ADDENDUM NO. 2

DATE: October 4th, 2017

PROJECT: Lancaster Regional Airport
New Terminal Building
Lancaster Texas

TxDOT CSJ No. 14TBLANCR-REBID

01 WALL SECTION

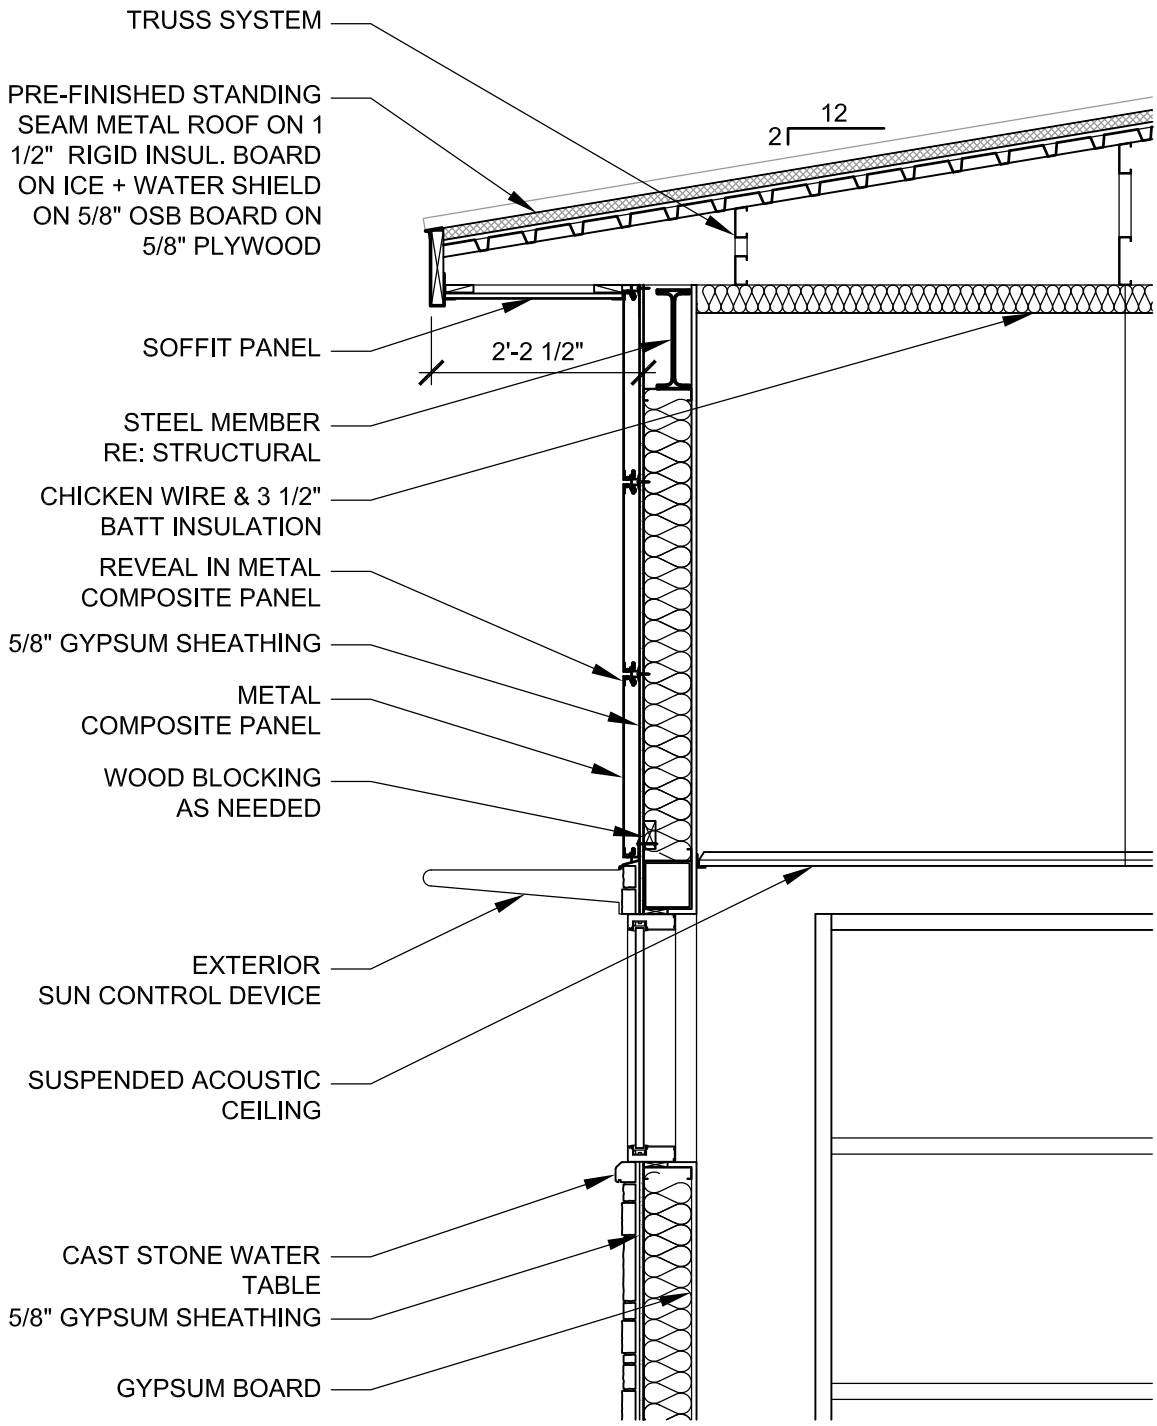
ASK2.01: See attached sketch for the addition of batt insulation along the bottom chord of the trusses resting on chicken wire. Extend gypsum board on interior of exterior wall to top of steel to contain exterior wall insulation. This sketch applies to all low roof areas/exterior wall sections.

02 WALL SECTION
1/2" = 1'-0"

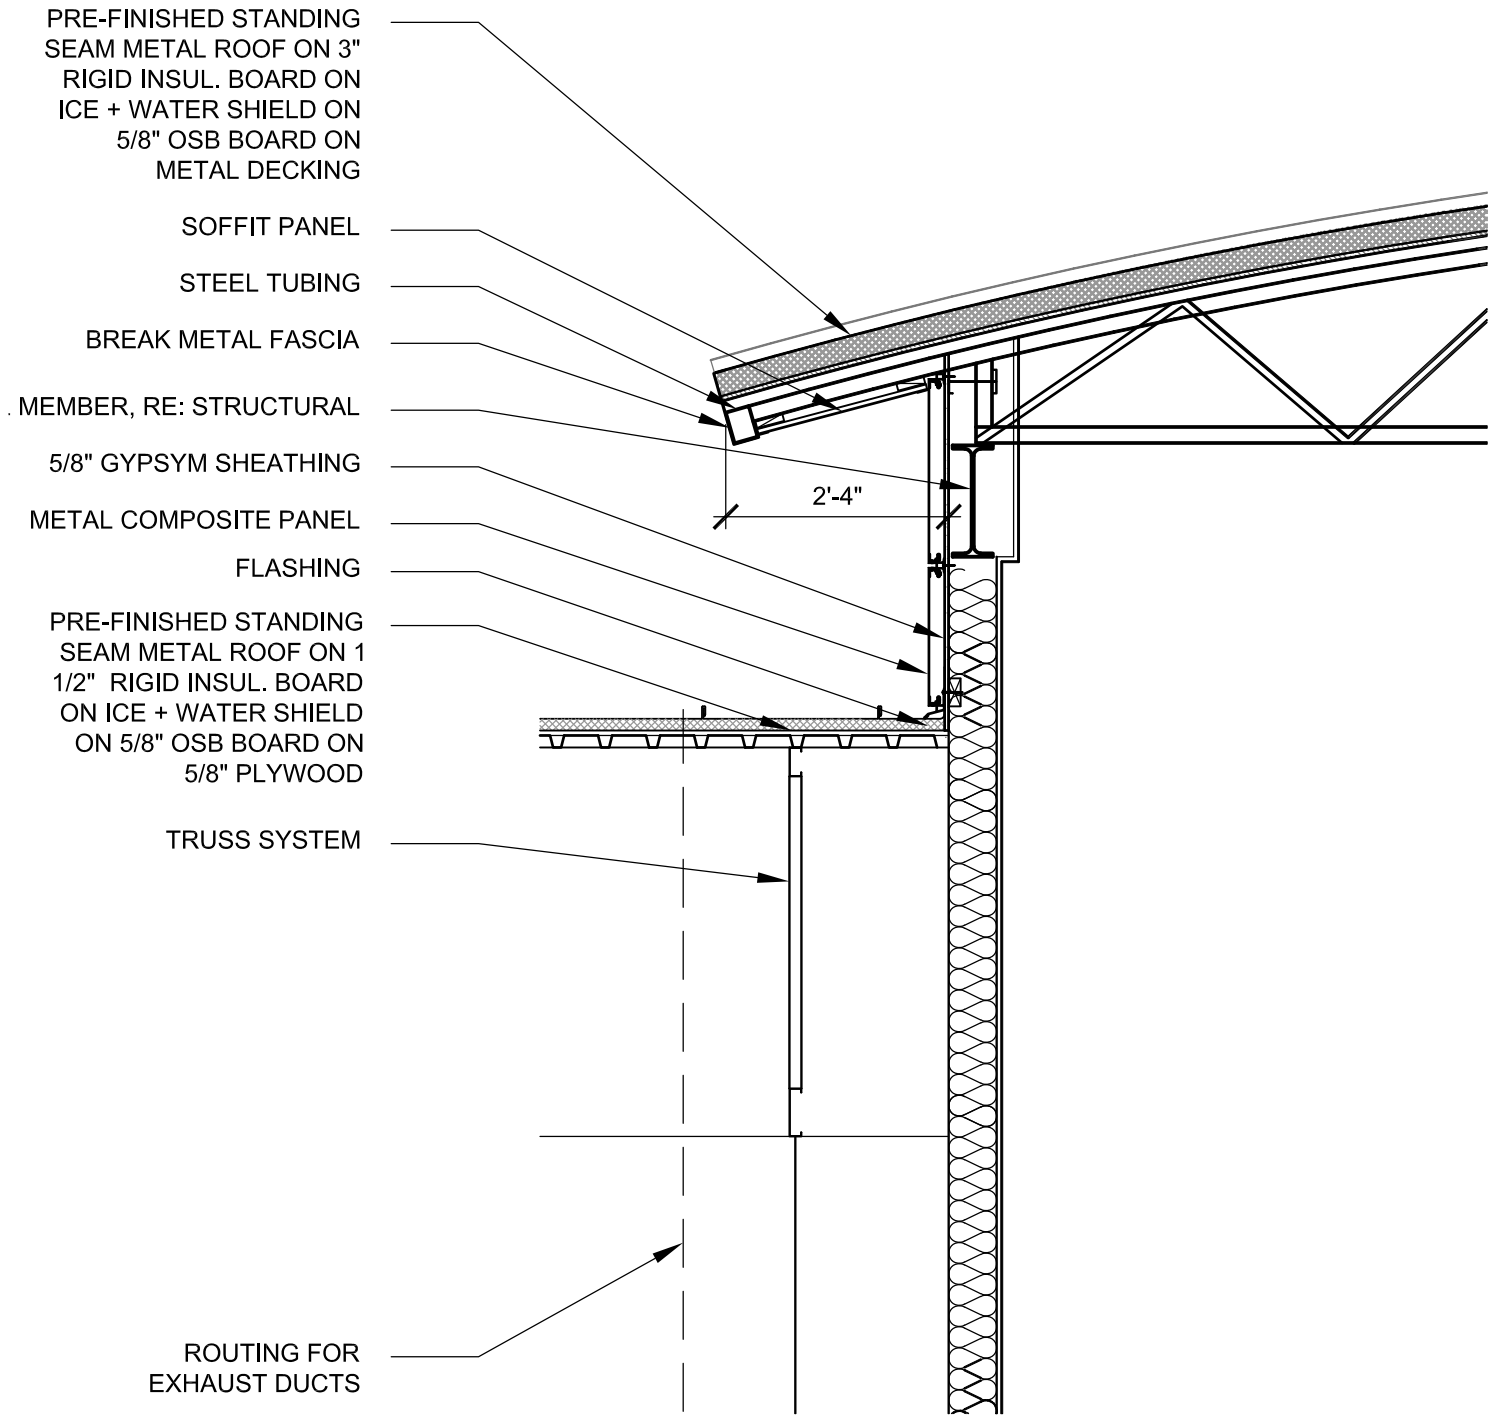
ASK2.02: See attached sketch for the addition of another layer of roof insulation board (total thickness now to be 3") at the curved roof area. This sketch applies to all high roof/curved roof areas/exterior wall sections.

01 FLOOR PLAN - REFERENTIAL

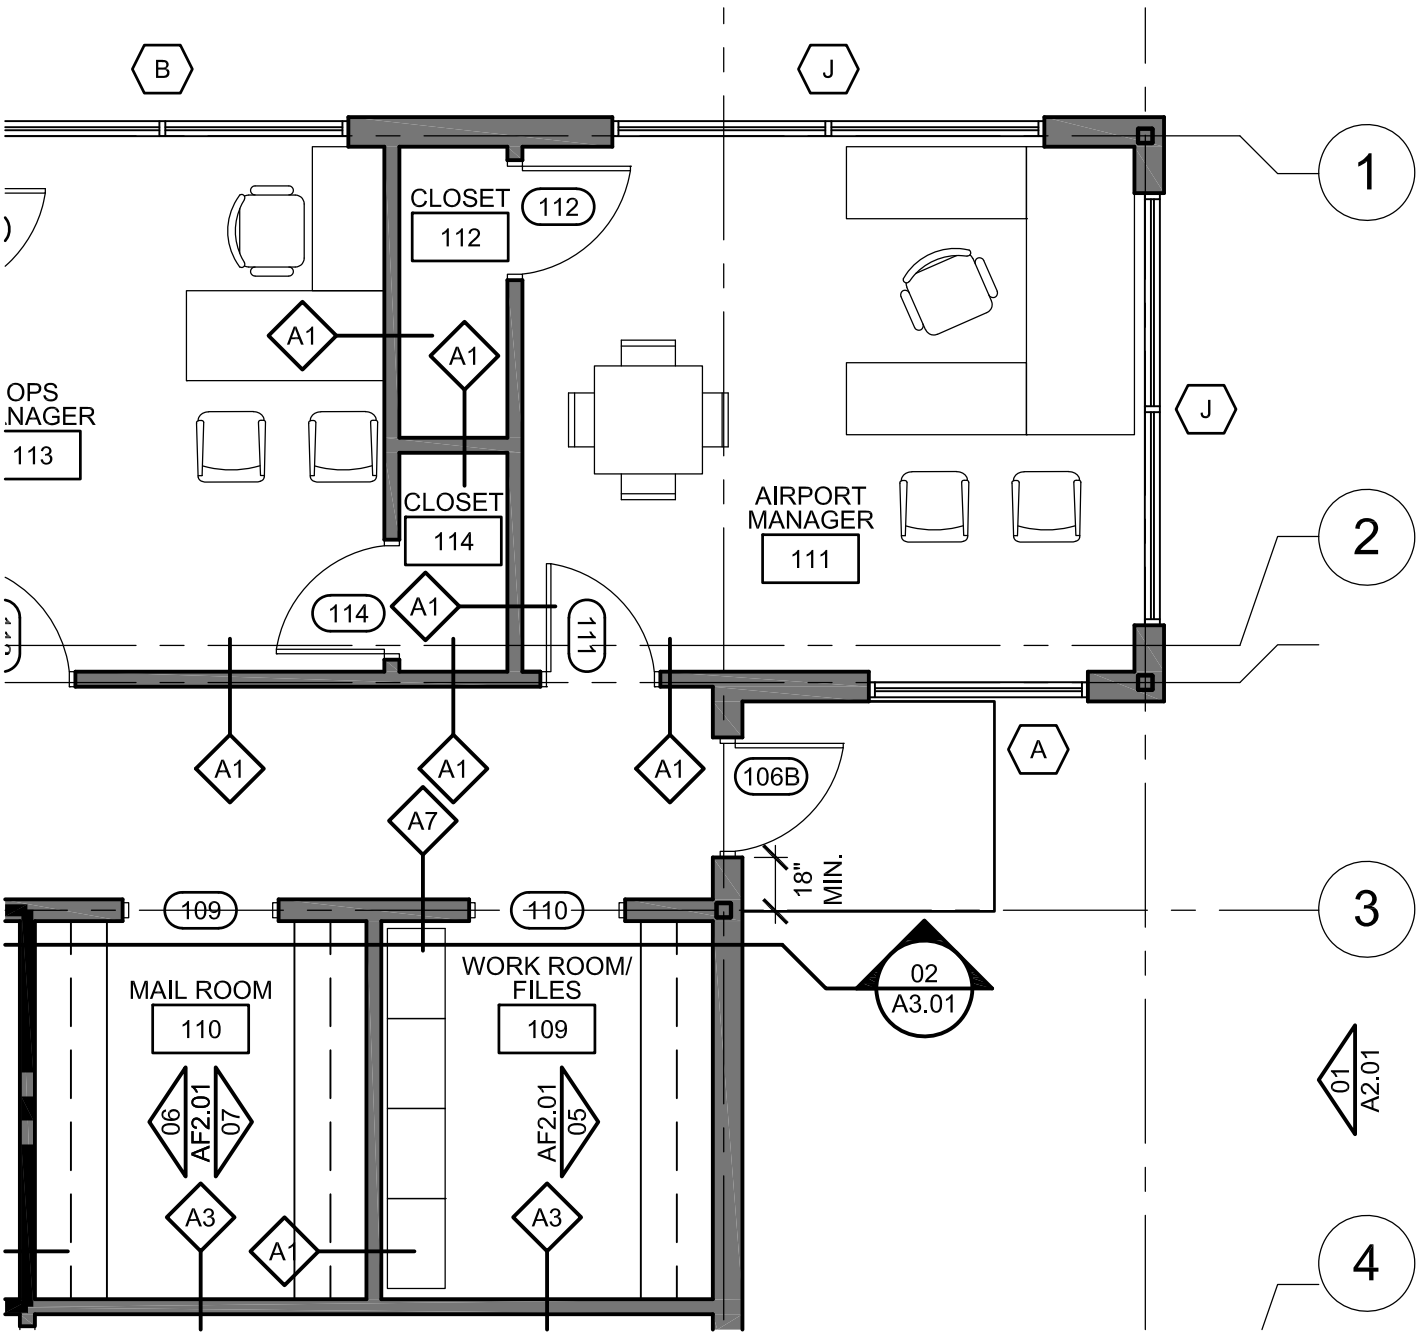
ASK2.03: See attached sketch for relocation of Door 106B.

01 FLOOR PLAN - REFERENTIAL

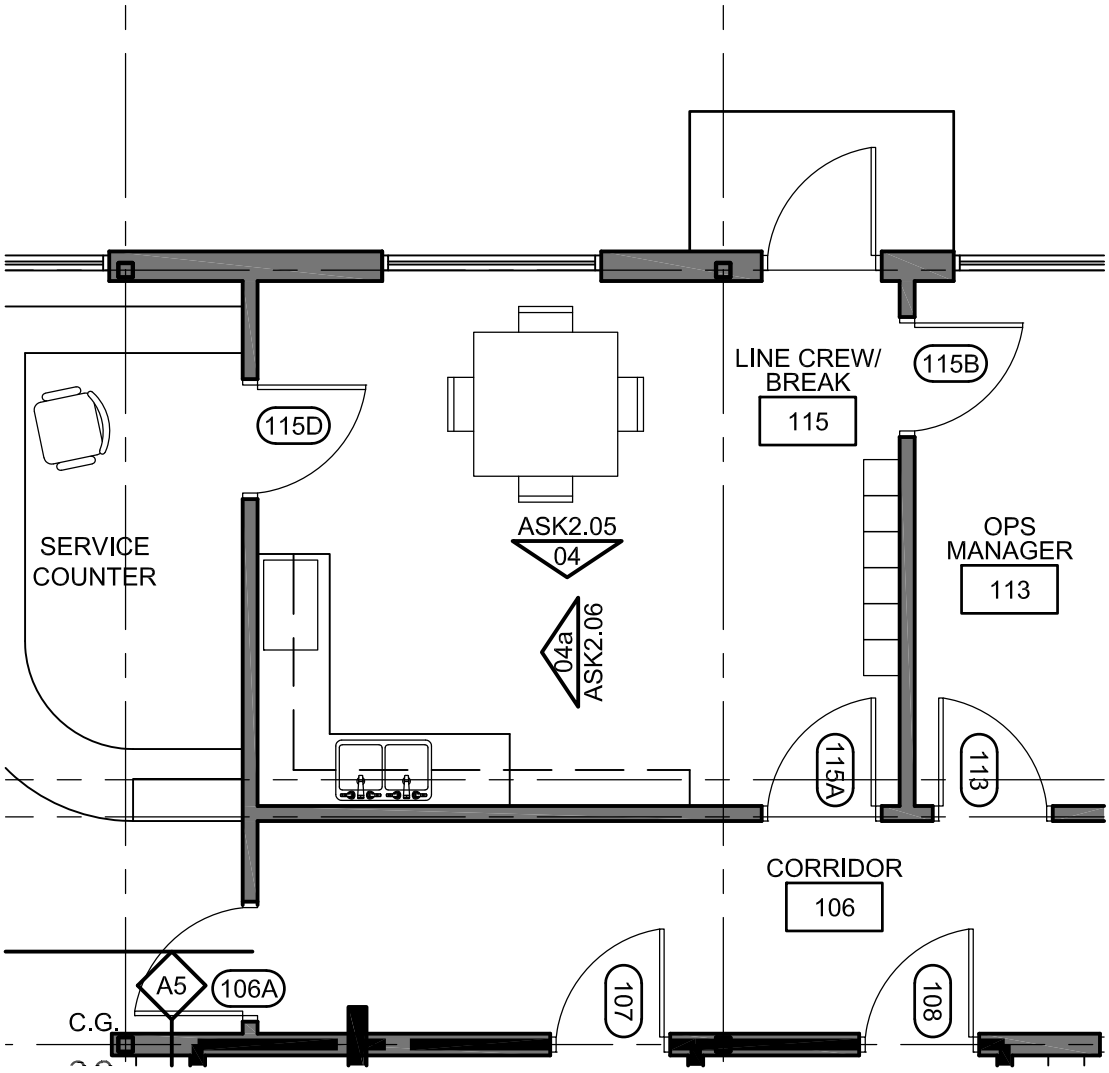
ASK2.04: See attached sketch for modifications at the millwork within the Line Crew/Break Area (115).

04 LINE CREW/ BREAK

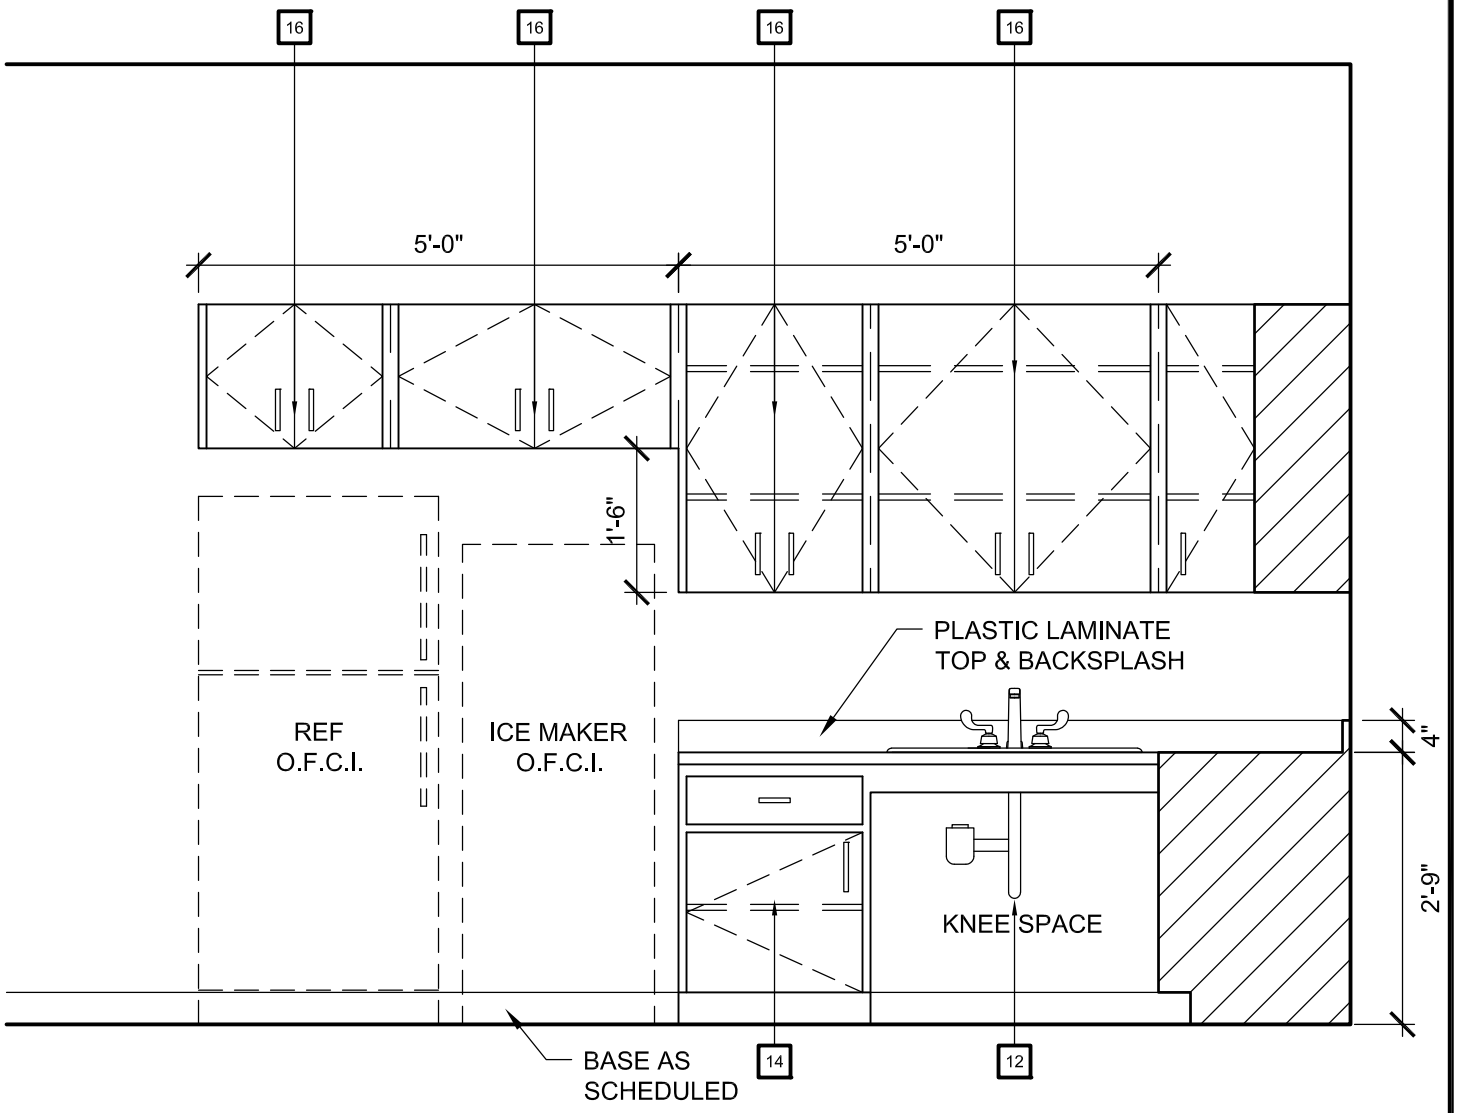
ASK2.05: See attached sketch for modifications at the millwork within the Line Crew/Break Area (115).

04a LINE CREW/ BREAK

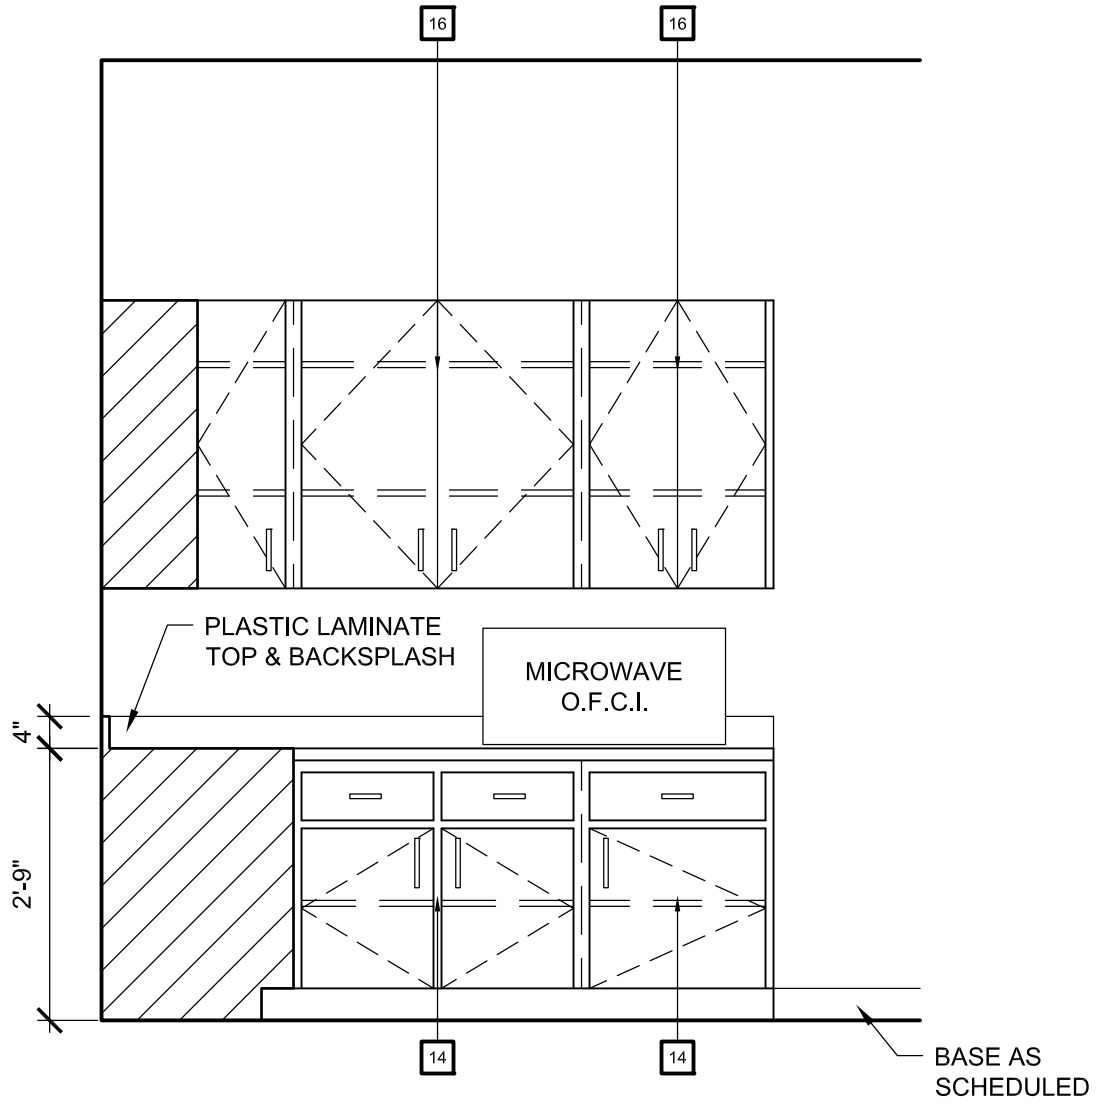
ASK2.06: See attached sketch for modifications at the millwork within the Line Crew/Break Area (115).
